# STAFF REPORT

RE: 2407 N. Roosevelt Blvd (permit application # T2019-7623)

FROM: Karen DeMaria, City of Key West Urban Forestry Manager

**From:** Karen DeMaria  
**Sent:** Friday, July 5, 2019 8:56 AM  
**To:** Owen Trepanier  
**Cc:** keith oropeza; Lauren Mongelli  
**Subject:** RE: 2407 N. Roosevelt Blvd Walkers Marina  
**Attachments:** T2019-0254 plans and Application 2407 N Roosevelt.pdf

Sheet Number:  
L-1.0

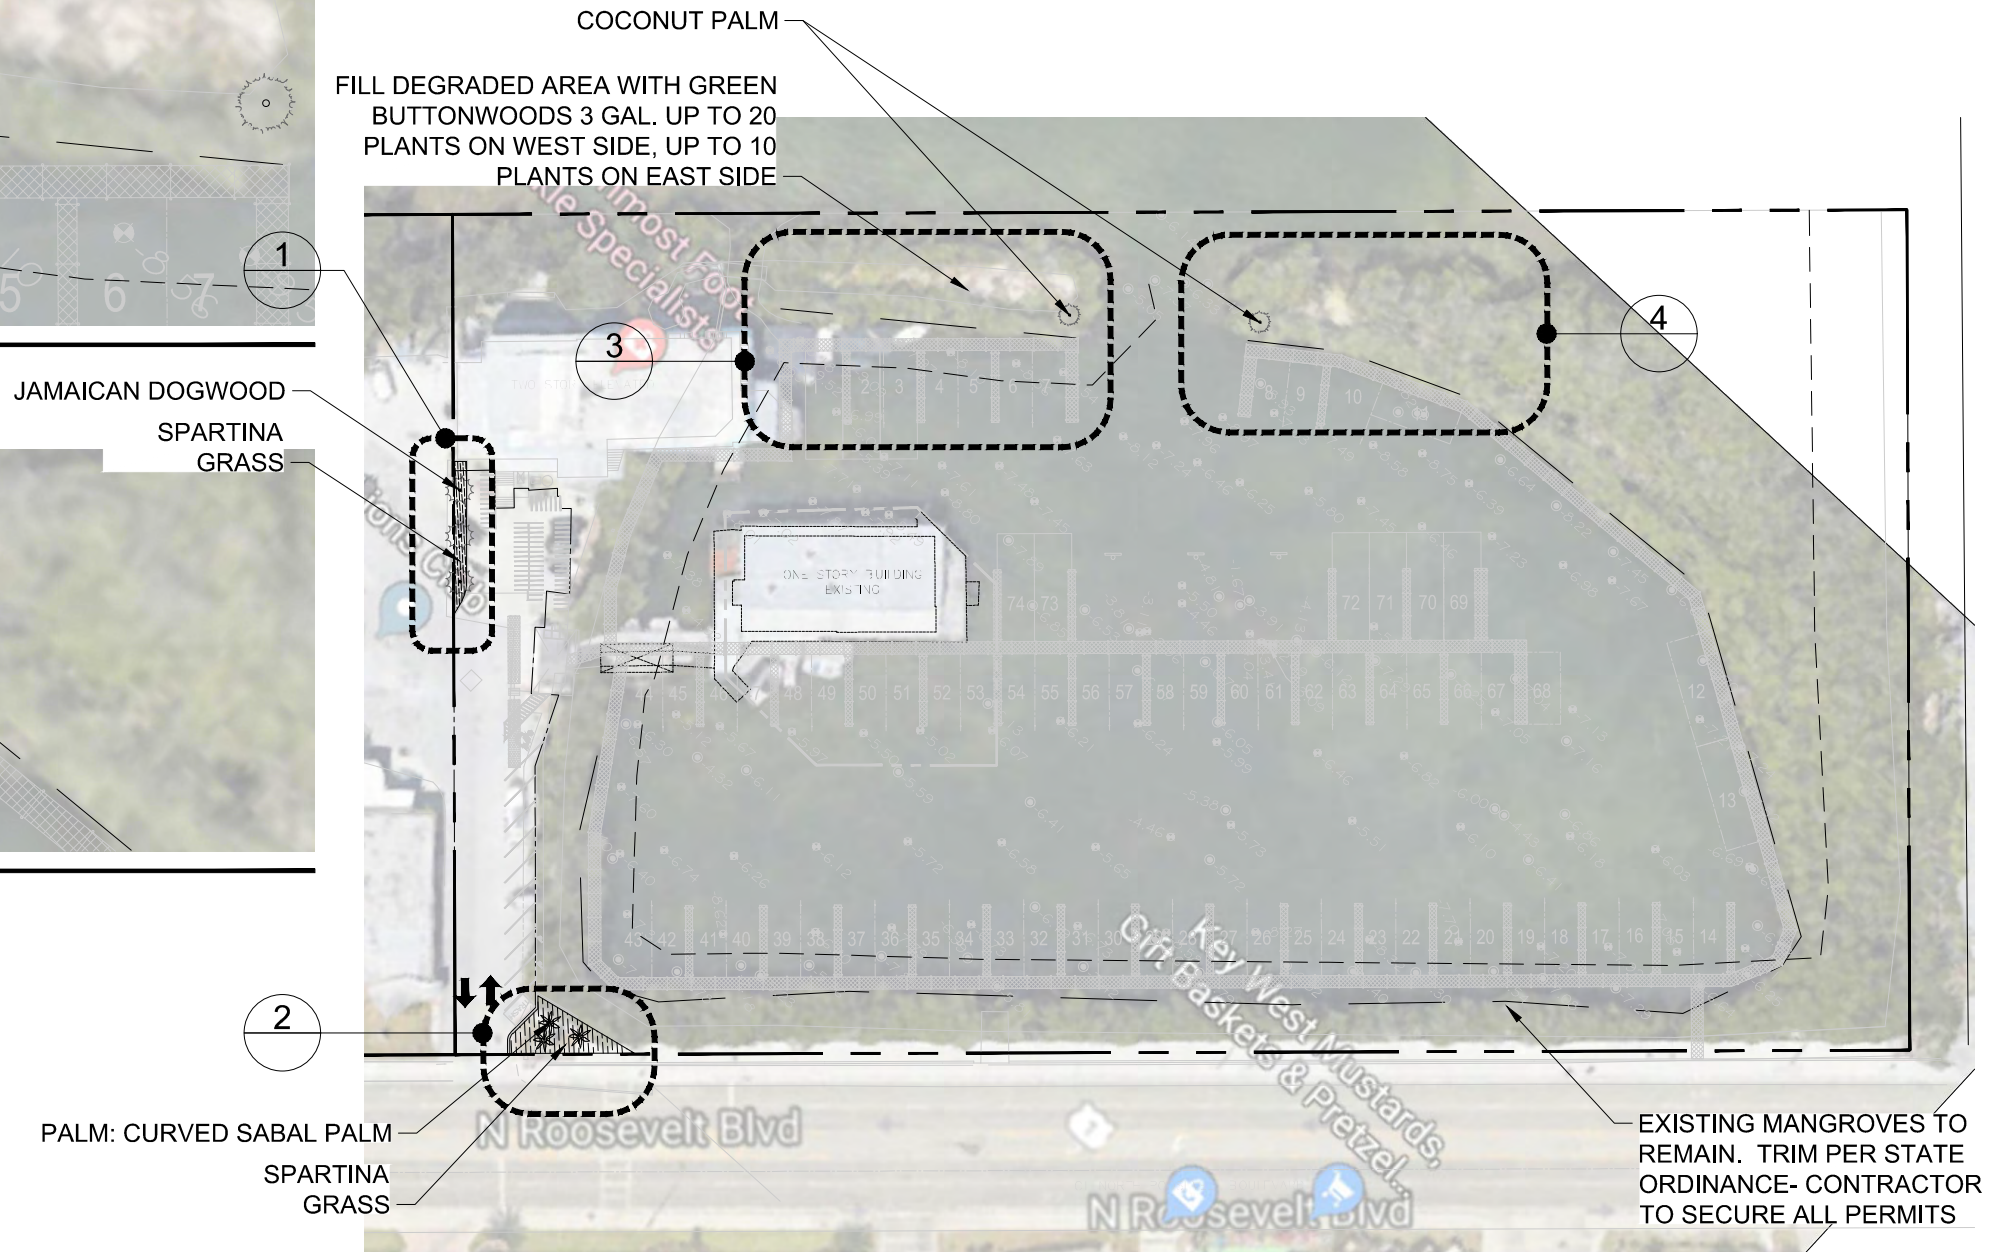
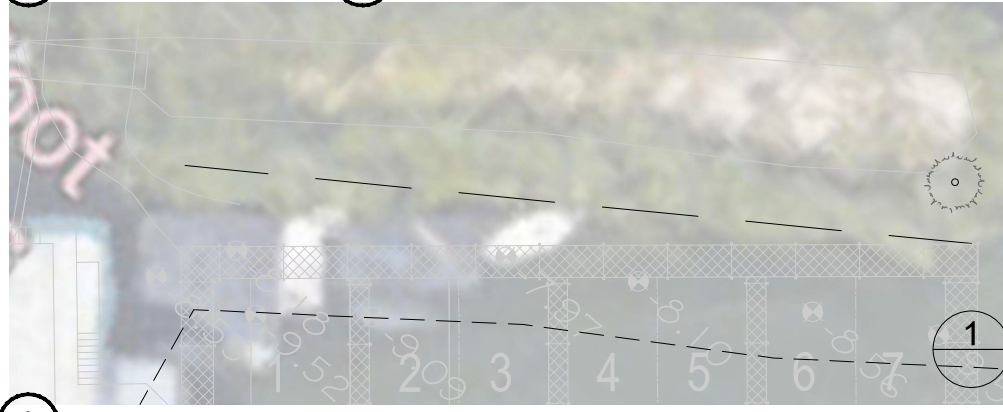
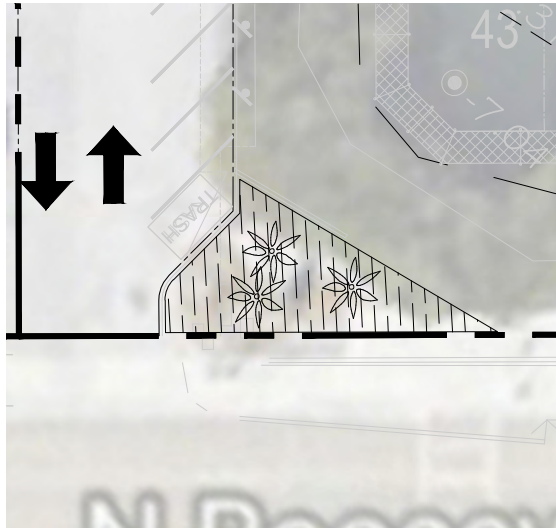
The property owner recently raised a question regarding the proposed planting areas 3 and 4 (mangrove berm area with an on grade walkway listed as fill degraded area in plans) and access and maintenance of this area if planted. The property owner indicated verbally that he did not support planting in these two areas. The representative submitted the plans to enhance these areas in January 2019 after discussion with the urban forester and the landscape architect.

- 1.The plans you submitted are dated October 2018. Is this correct? Were there any updates or changes during the Planning Board review?
- 2.The landscape plan needs to be signed and sealed drawings. What I have is not.
3. Please confirm the location of the Jamaican dogwood planting area (area 1), its dimensions and whether it is actually located on the property. Page C-2.0 and other pages make it look like this planting area is not on this property.
4. Please document and confirm access to the proposed planting areas on the berm area (area 3 and 4). What does this area look like, is it suitable for plantings, and will the plantings survive. There is a question regarding access to this area to do the work.

1. We confirmed there were no changes to the landscaping plan that resulted from the planning board approval process. They also granted the landscape modification.
2. I'm asking Keith if he can electronically sign the plan.
3. The planting area along the West property line, in the parking lot, is 5'x40'. It is wholly contained on the property. It has been enlarged from the previous (existing) approval, which was 5'x27'. There was no specific reason for the enlargement other than we found it could be enlarged, so we enlarged it.

4. Here is picture of the berm behind Walker's building. As you can see, it isn't appropriate for many species given its low elevation, which is why Keith chose coconut palms as features and buttonwoods to plant the degraded areas. As I mentioned, the West side is easily accessible. The East side has an ephemeral homeless encampment

in the degraded area with a trail which we will block off and prevent access after the planting is complete. Watering and maintenance will occur on a regular schedule via maintenance boat.

1. There were no changes from planning board.
2. I'll ask Keith to send a signed and sealed set.
3. We'll confirm
4. The West side is easily accessible. The East side has a homeless encampment trail which we will block off and prevent access after the planting is complete. Watering and maintenance will occur, in the future, via maintenance boat.

Sheet Number:  
**C-1.0**

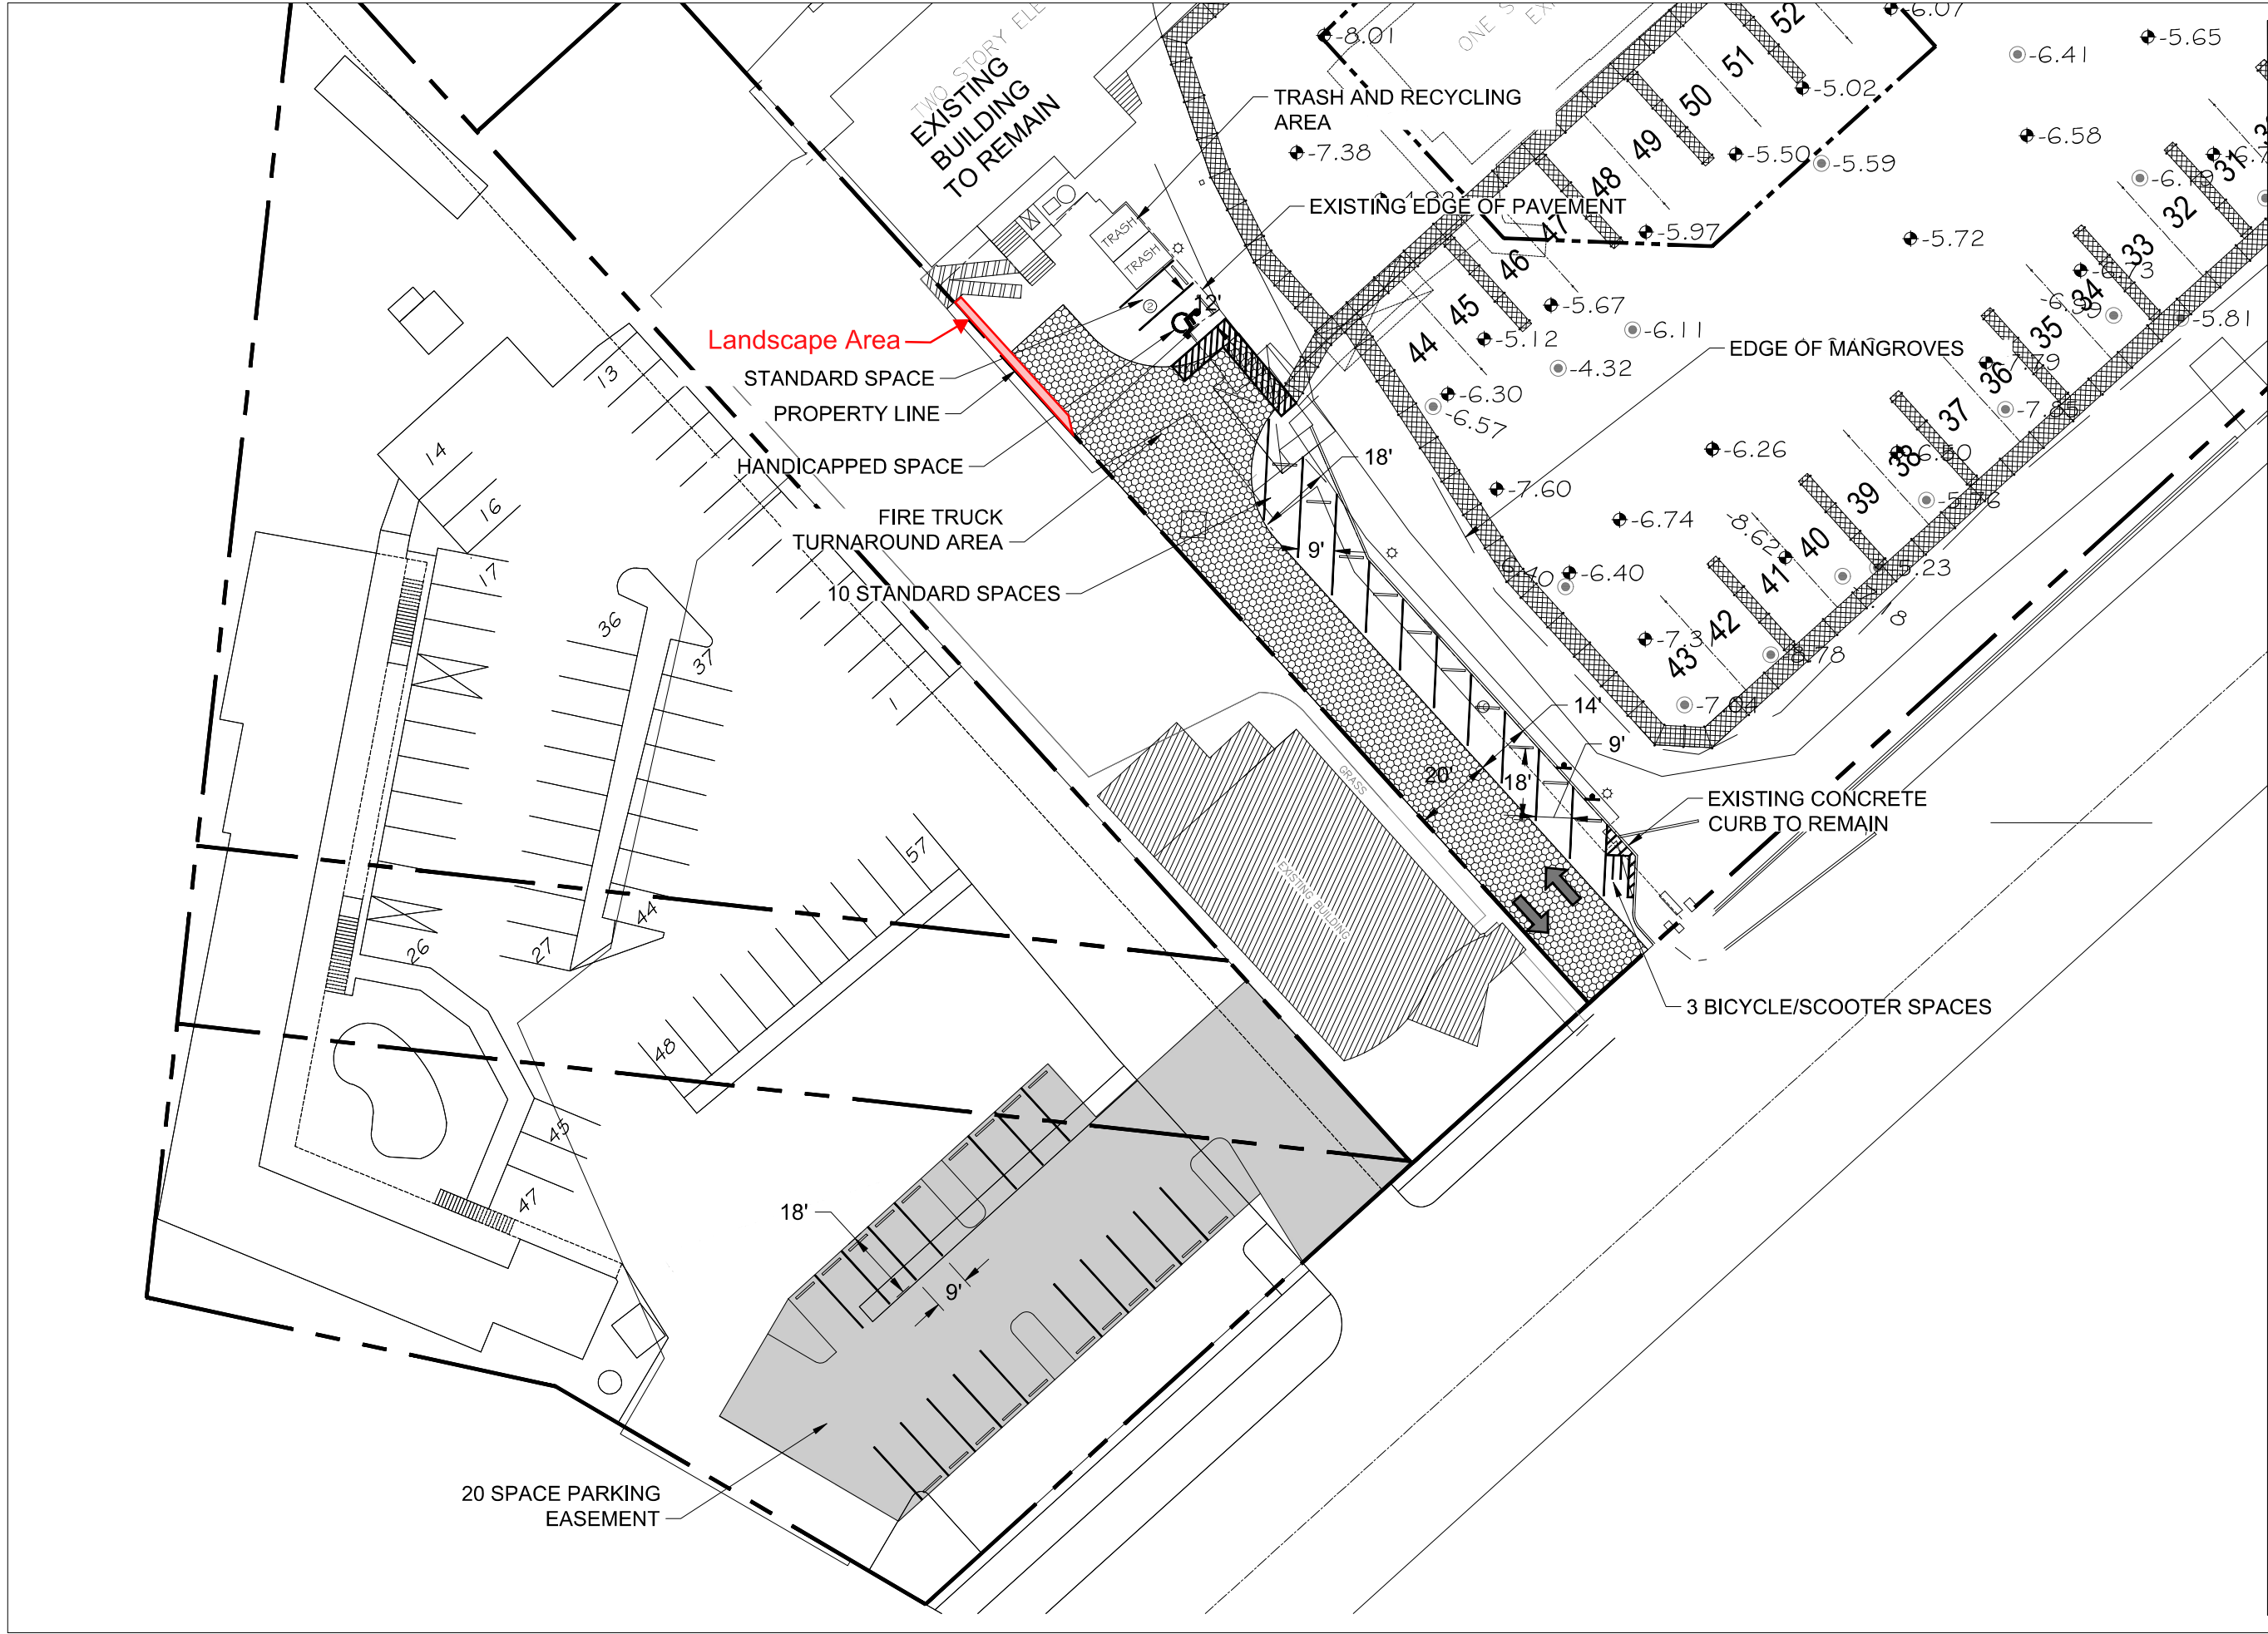
Proposed parking plan C-2.0 and Proposed Site Plan C-1.0 as they do not show the landscape area clearly. It actually looks like there is no landscape area on these two plans.
